# SURFACE WATER DRAINAGE ASSESSMENT & OUTLINE SUDS STRATEGY

39 FITZJOHNS AVENUE  
CAMDEN

Metis have now (September 2021) requested additional clarification on three items and this report has been updated to address these. A comments tracker is appended to this report.

## SUDS COMMENTS TRACKER

A schematic plan of the proposed SuDS features on site, which would provide the necessary attenuation storage, is presented overleaf.

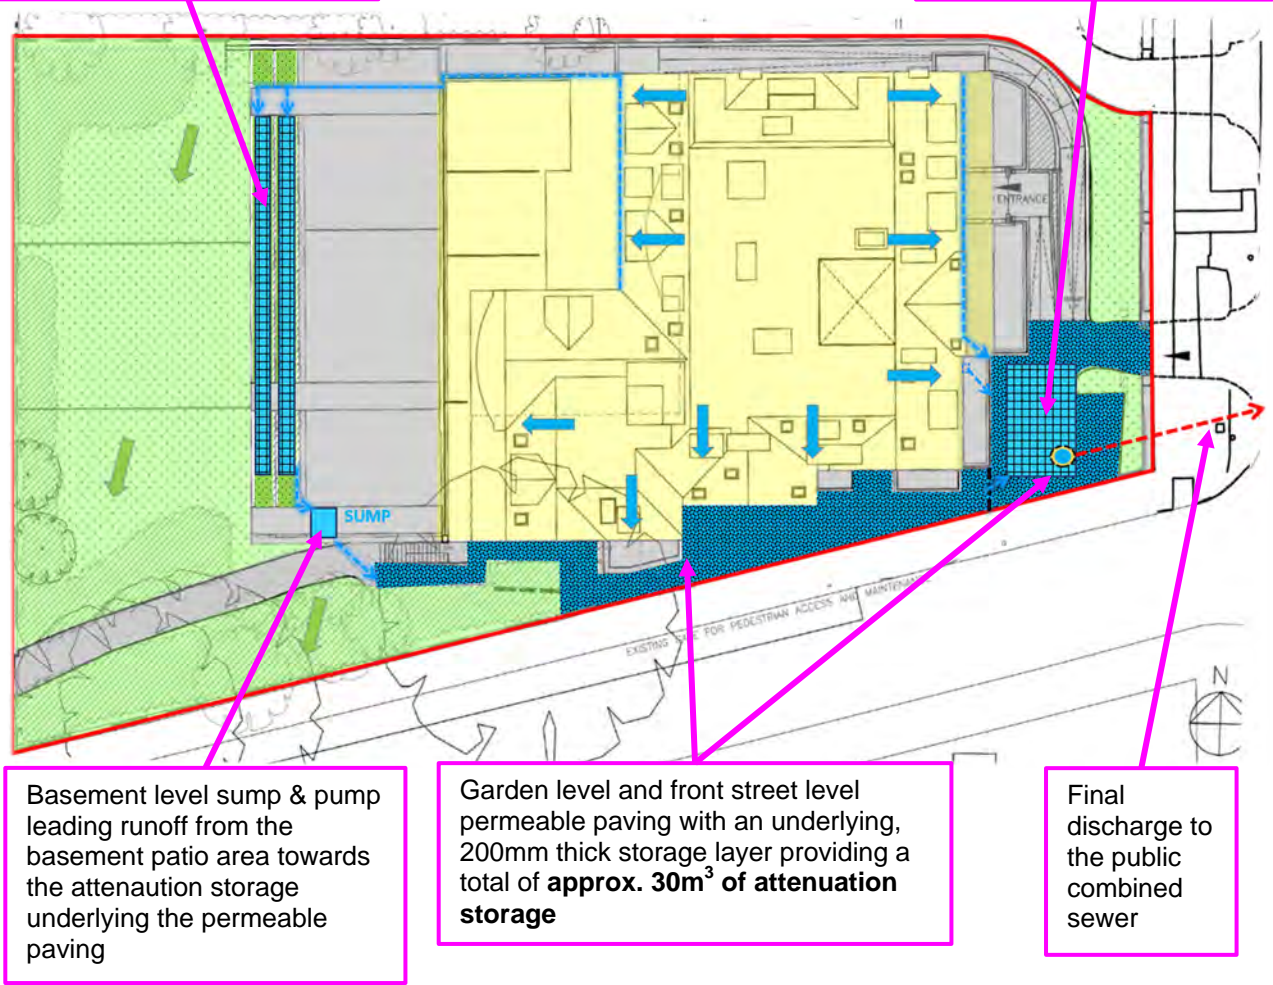
REF.	LLFA COMMENT 26.07.2021	LBHGEO RESPONSE 03.08.2021	LLFA COMMENT 09.09.2021	LBHGEO RESPONSE 20.09.2021
3	Increase the amount of attenuation storage so that the amount proposed is equal to or greater than that required.	The proposed storage volume has been increased to achieve runoff equivalent to the calculated greenfield runoff rate.	Resolved.	
4	Supply evidence for a Thames Water Asset Location Search.	An extract from a Thames Water Asset Location Search is included in the report for purposes of identifying the nearest sewers to the site.	Needs clarification – is it the plan on P12 of SuDs assessment? Include a simple reference such as ...Extract from Thames Water Asset Location Search.	The extract from the Thames Water Asset Location Search is indeed presented on page 12 of the SuDS Assessment. A reference has been added for clarification.
5	Supply information detailing the management of Health and Safety risks related to the SuDS design.	There is no requirement to provide this information as part of the planning application, in accordance with the Camden Local Plan and the Water & Flooding Camden Planning Guidance (CPG).	We do not agree with this stance – but will not pursue these details in this instance in order to progress.	Noted.

Attenuation storage tanks underlying stepped planting providing **approx. 42m<sup>3</sup> of storage**

Underground attenuation storage tank providing **approx. 40m<sup>3</sup> of storage**

Garden level and front street level permeable paving with an underlying, 200mm thick storage layer providing a total of **approx. 30m<sup>3</sup> of attenuation storage**
